PRODUCT CHANGE NOTIFICATION

ICR-3200 Rev.2.1

Product Identification

Figure 1: Revision on the Packaging Label

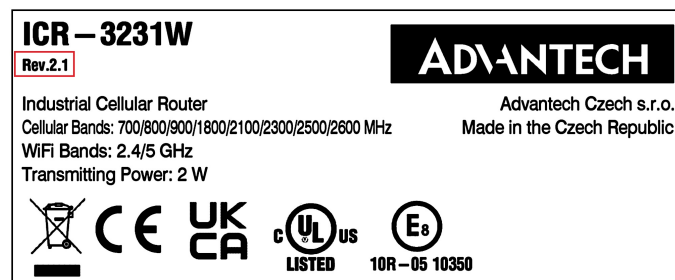
- **ICR-3200** product family
 - Affected products: All variants of ICR-3201, ICR-3231, ICR-3232 and ICR-3241.
- See the product revision number on the packaging box or the product label to identify affected routers. Affected routers have the product revision *Rev.2.1*; see Figure 1 and Figure 2.
- The router GUI can also display the product revision under *Status -> General -> System Information -> Product Revision*. Please note that the default revision (*Rev.1.0*) is unavailable here.
